Function: Short MC2.14 (VREFP) to MC2.16 (GNDADC) to select the XEM8305 internal SYSMON ADC reference.

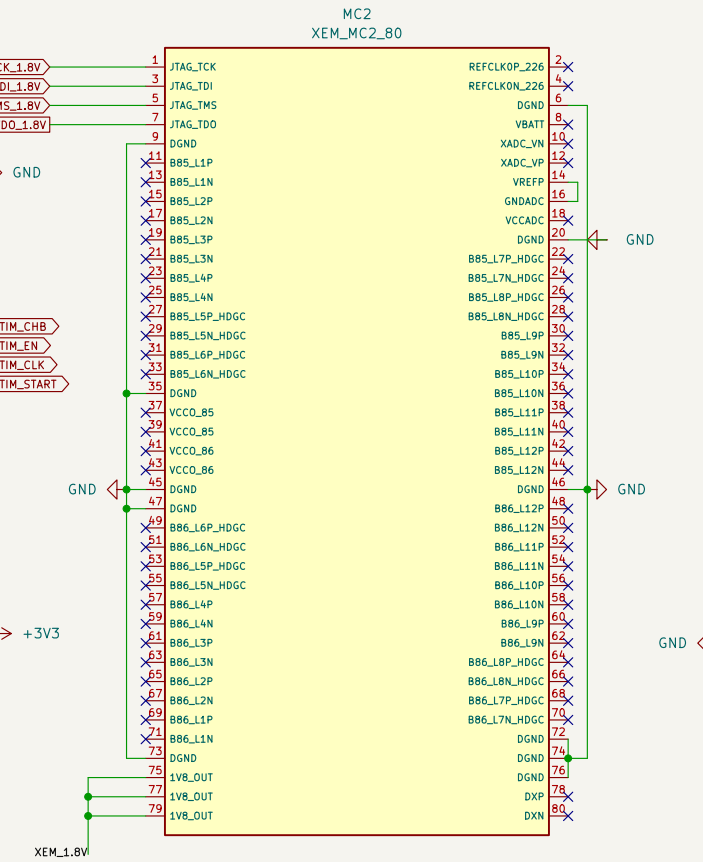
Source / changes: Opal Kelly XEM8305, Expansion Connectors, SYSMON; web page accessed 31 Oct 2026: https://docs.opalkelly.com/xem8305/expansion-connectors/ Codex V6 adds direct copper instead of a removable 0-ohm link. Module C168 remains its default 0.1uF. GNDADC retains the module FB2 return; no carrier GND or MC2.18 (VCCADC) tie is added. External-reference use would require removing this short.
